*TOLEDO CITY
PLAN COMMISSION
REPORT*

January 8, 2015

**TOLEDO-LUCAS COUNTY PLAN COMMISSIONS
APPLICATION DEADLINE, AGENDA, STAFF REPORT AND HEARING
SCHEDULE - 2015**

MAJOR SITE PLAN REVIEW
TOLEDO CITY PLAN COMMISSION
REF: SPR-58-14
DATE: January 8, 2015
TIME: 2:00 P.M.

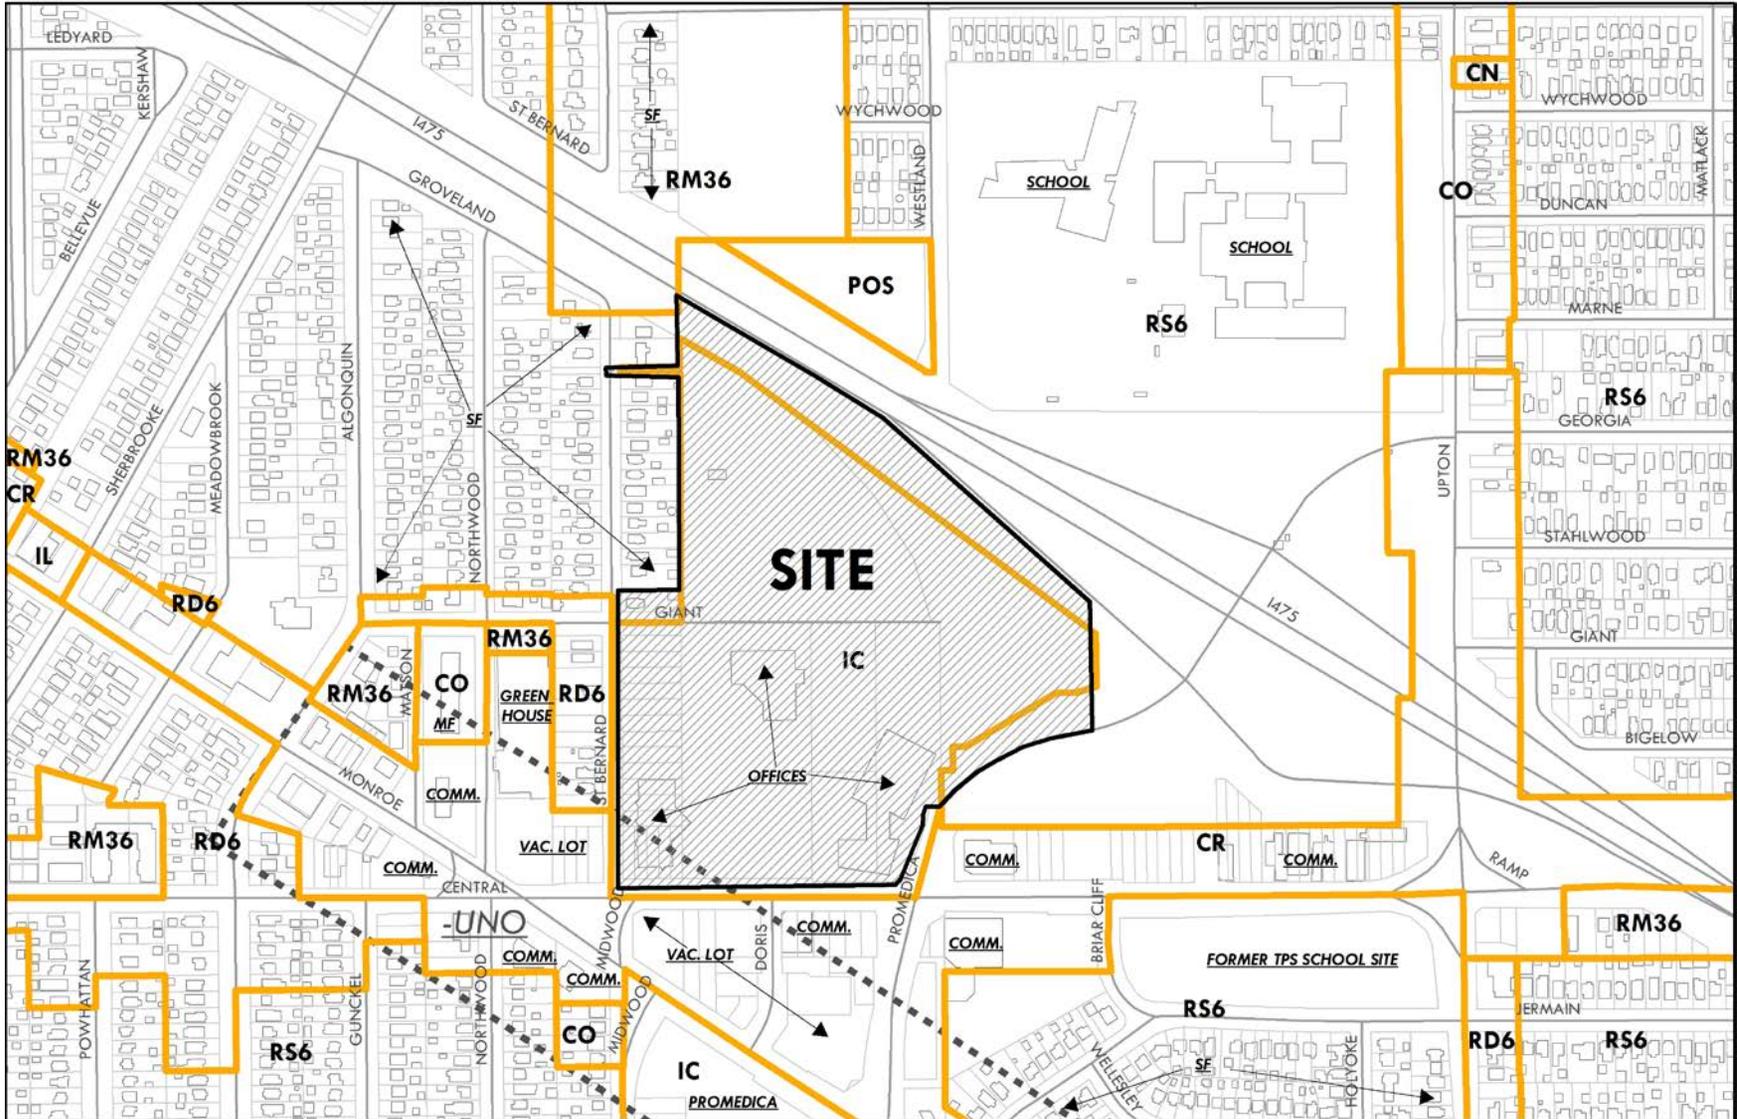
26. **A dry extended detention basin is proposed on the plans submitted to treat the required water quality volume (WQv). However, since the site is greater than 5 acres of disturbed activity, dry basins must include forebay and micropool, each sized at 10% of the WQv.**

33. Dumpster location(s) shall be clearly defined, have a concrete pad and be surrounded by a solid wooden fence or a masonry screen enclosure with landscaping and shall not be located in any required setbacks. **Acceptable as depicted on site plan.**

35. A detailed site, lighting, sign, fencing and landscaping plan (**landscape plan as submitted is acceptable**) shall be submitted to the Plan Director for review and approval. Such plan shall include:
 - a. One tree is required for every 500 square feet of building coverage, or fraction thereof, for all structures. Greenbelt Frontage trees are included in this total, minimum of two trees in the front and side yards. Foundation plantings for the full street facing building elevation; and landscape areas at major building entrances; **acceptable as depicted on landscape plan.**

- b. Total interior landscaping shall be 20 square feet per parking space. Landscape areas within the parking area shall be peninsular or island types and must be constructed with 6 inch by 18 inch concrete curbing; **acceptable as depicted on landscape plan.**

- c. All parking spaces must be within 100 linear feet of a landscaped area; **acceptable as depicted on landscape plan.**

- d. All landscaped areas must have a minimum dimension of at least 9 feet and be at least 160 square feet in area; **acceptable as depicted on landscape plan.**

- f. Landscaped areas may not contain bare soil, aggregated stone or decorative rock. Any ground area must be covered with hardwood mulch, grass or other vegetative ground coverage; **acceptable as depicted on landscape plan.**

- g. Landscape terminal islands must be provided at the end of each parking row; **acceptable as depicted on landscape plan.**
- h. Two canopy trees and six shrubs are required to be installed in interior landscape areas for each 10 parking spaces within the parking lot; **acceptable as depicted on landscape plan.**

- i. Frontage greenbelts shall be constructed of grass, trees and shrub plantings. Greenbelt frontage landscaping shall be a minimum width of 15 feet, constructed of a solid evergreen hedge and provide a minimum of one tree for every 30 feet of frontage. Trees are not required to be evenly spaced and may be clustered; **acceptable as depicted on landscape plan.**

- j. Perimeter landscaping must be installed along any parking lot area adjacent to a street, place or driveway, or which is visible from an adjacent property, and shall be ten feet (10') in width; **acceptable as depicted on landscape plan.**

- m. **If applicable;** the location, height and materials for any fencing to be installed and maintained. Where screening is required, fence shall be solid board-on-board and shall be depicted as such in revised landscape plan.

SITE PLAN

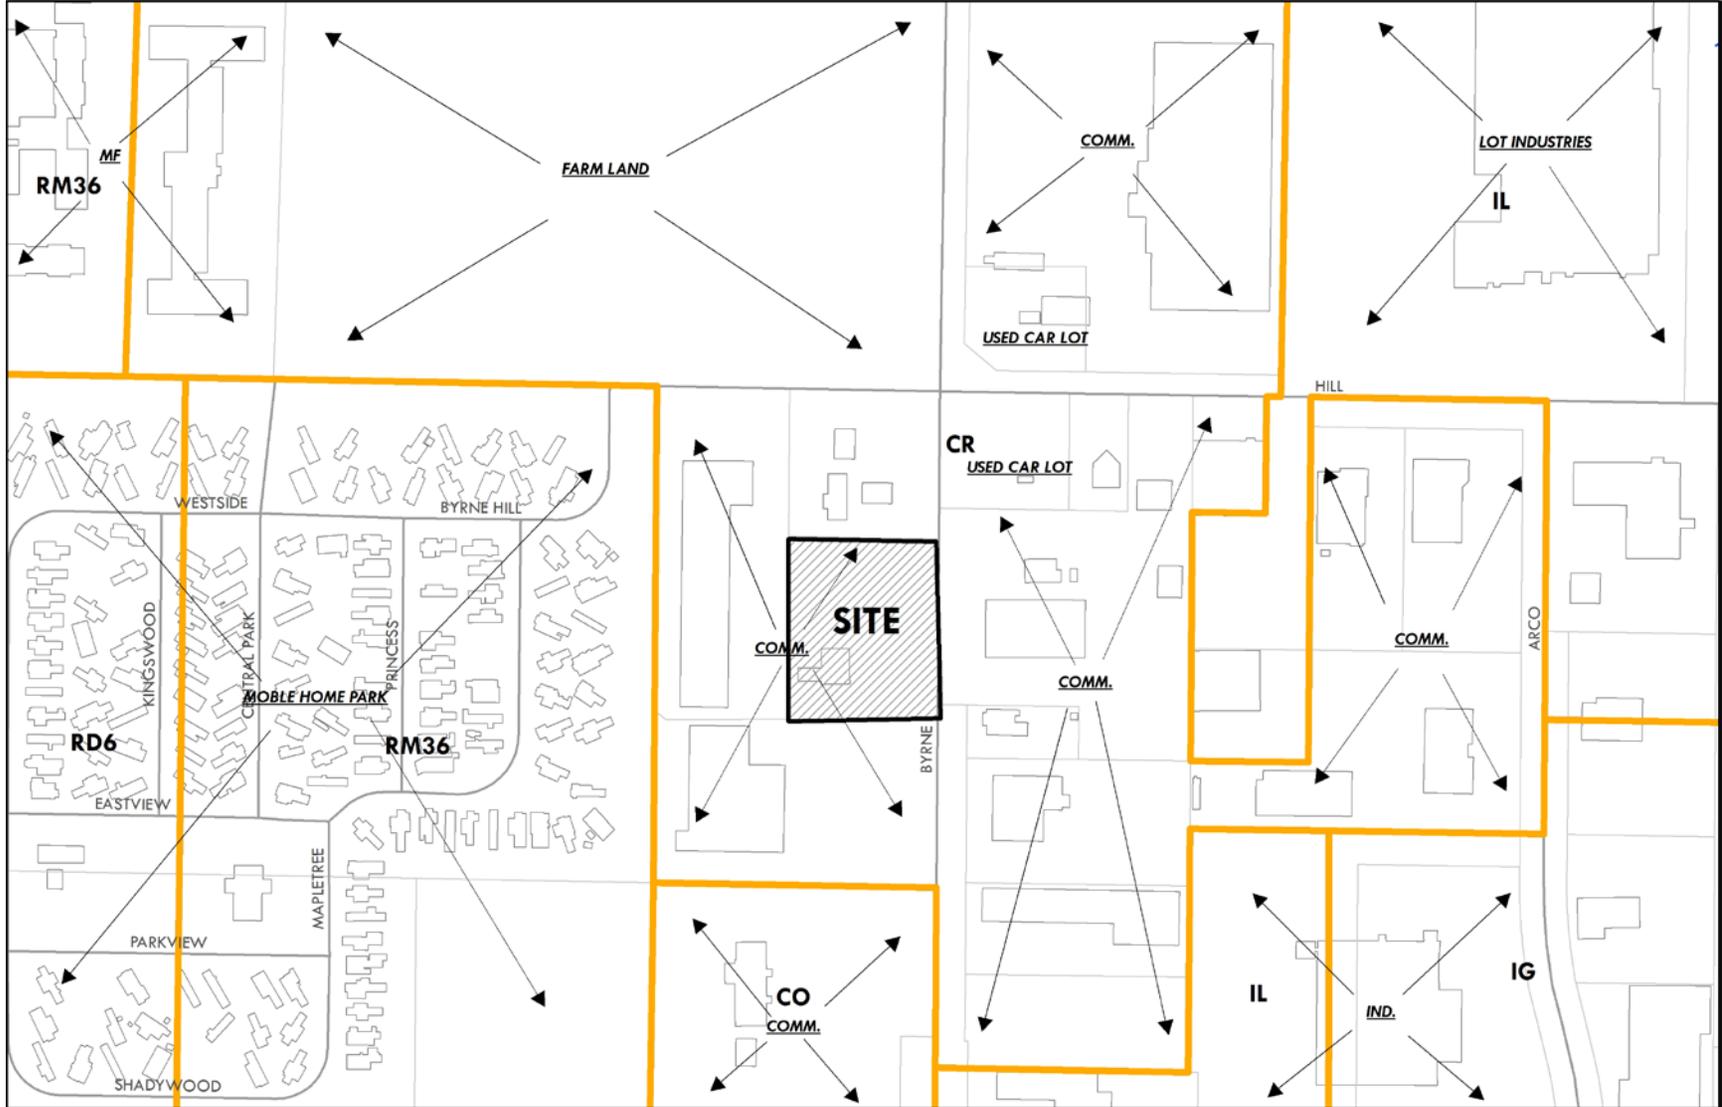
6. The Division of Transportation requests clarification for the proposed use of the former drive-thru area prior to approval of the site plan.
7. If not already established, formal cross access agreements shall be established with the adjacent property owners.

14. Repairs and services of vehicles shall be conducted wholly within an enclosed building permanently located on the site.
15. The existing carport/drive-thru area shall be removed, **shall be noted on revised site plan.**

16. A dumpster location(s) shall be noted on a revised site plan and have a concrete pad surrounded by a solid wooden fence or a masonry screen enclosure with landscaping and shall not be located in any required setbacks.

- a. A 15' Greenbelt is required along the Byrne Road frontage and shall include one tree for every 30' of lot frontage and a solid evergreen hedge; **shall be noted on revised landscape plan.**

- b. The existing landscape islands along the western property line shall be extended in the areas of the drive-thru curb cuts, these areas shall be a minimum of five (5) feet in width; **shall be noted on revised landscape plan.**

SITE PLAN

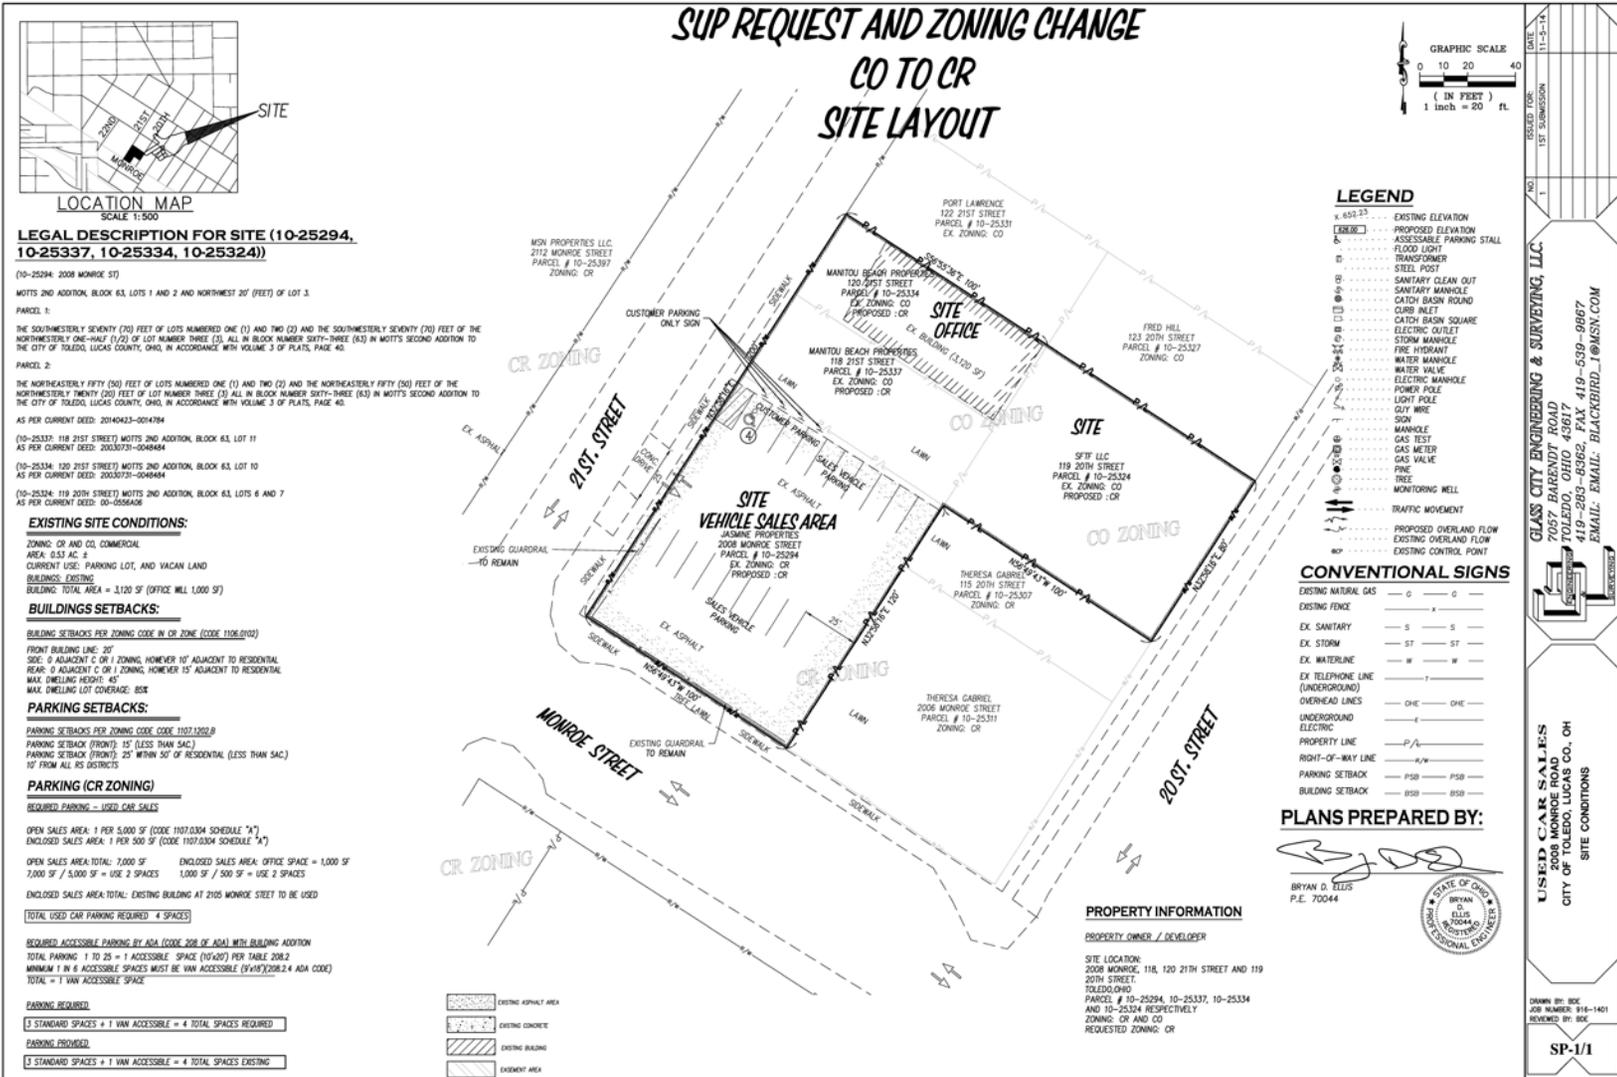
The applicant is requesting a waiver of the minimum 5 foot width frontage greenbelt and solid 3½ foot high aluminum tube fence, wrought iron fence, brick or stone wall requirement along Monroe Street and along 21st Street parking area frontage. The construction of new off-street parking lots having frontage on Monroe Street is prohibited in the Monroe Street Corridor Urban Neighborhood Overlay District. For existing development, parking may be allowed on the side of the principle building if proper screening wall and landscape treatment area are installed along the frontage. The applicant is proposing to leave the existing parking area intact and utilize the existing guardrail. **Staff does not support approval of this waiver.**
